## Product Change Notification

1. ECN #: 243782

- TFM - .050 X .050 MICRO STRIPS
- TFML - .050 SHROUDED TERMINAL

TFM ASSEMBLY WITH "TAIL WITH" AND "TAIL WITHOUT" COIN

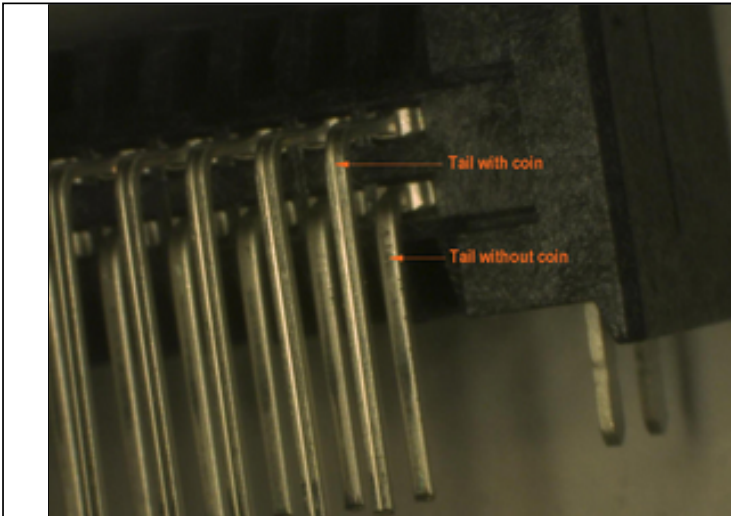
ADDED LONGITUDINAL COIN TO ONE SIDE OF TAIL TO AID STRAIGHTNESS

CUSTOMER CAN SEE WHAT APPEARS TO BE A SCRIBE LINE DOWN THE LENGTH OF THE TAIL ON ONE SIDE

EXISTING PIN WITHOUT COIN

REVISED PIN

COINING KEEPS THE TAIL STRAIGHTER, THIS IS A DESIGN IMPROVEMENT AND IS BEING IMPLEMENTED AS A RUNNING CHANGE, THERE COULD BE MIXED GENERATION PINS WITHIN THE SAME PART AND SHIPMENTS COULD ALTERNATE FROM EXISTING TO REVISED AND BACK TO EXISTING DEPENDING ON INVENTORY LEVELS OF THE SPECIFIC PINS INVOLVED.
